DESIGN REVIEW BOARD

September 9, 2025
7:00 PM

FINAL AGENDA

AGENDA ITEM REPORT
September 9, 2025

REVISED FRONT ELEVATION

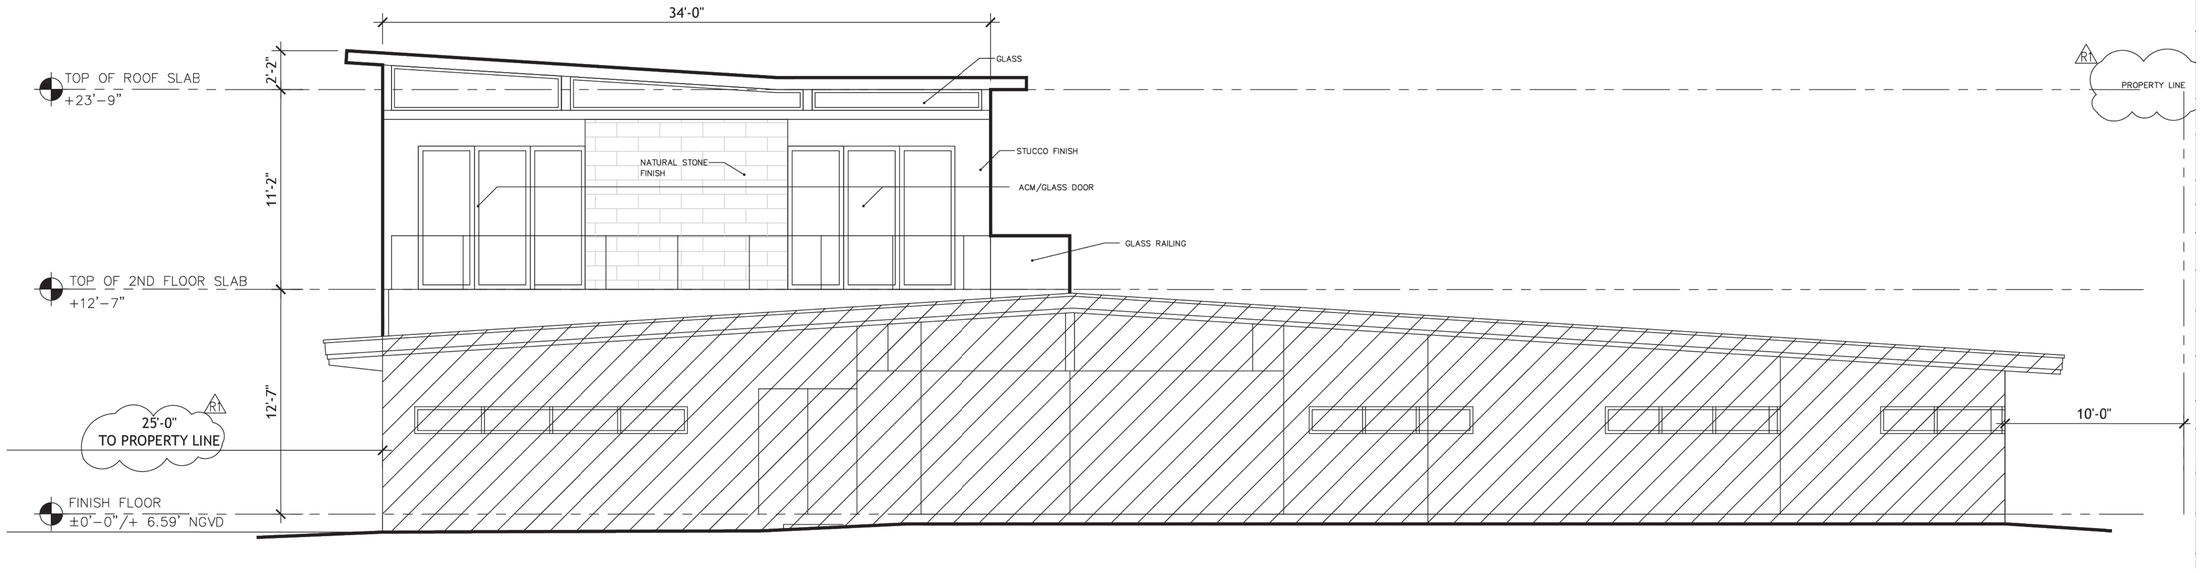
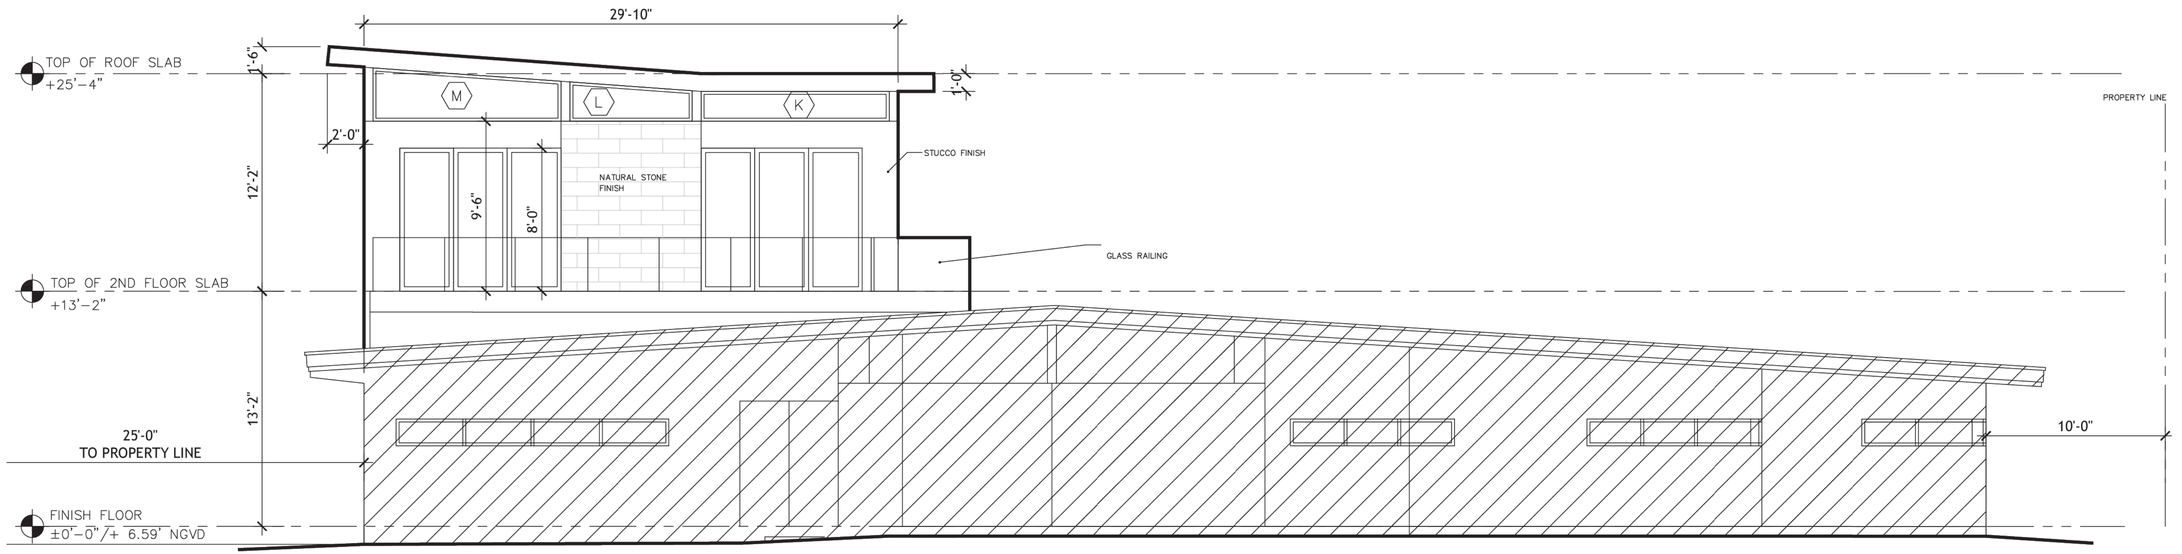
8) On Sheet A3.0 of the BP plan set (Building Elevations) the "West Elevation" illustration is missing. This was included and required to be included in the approved DRB plan set. Revise the plan to include the missing West Elevation. Note any changes.
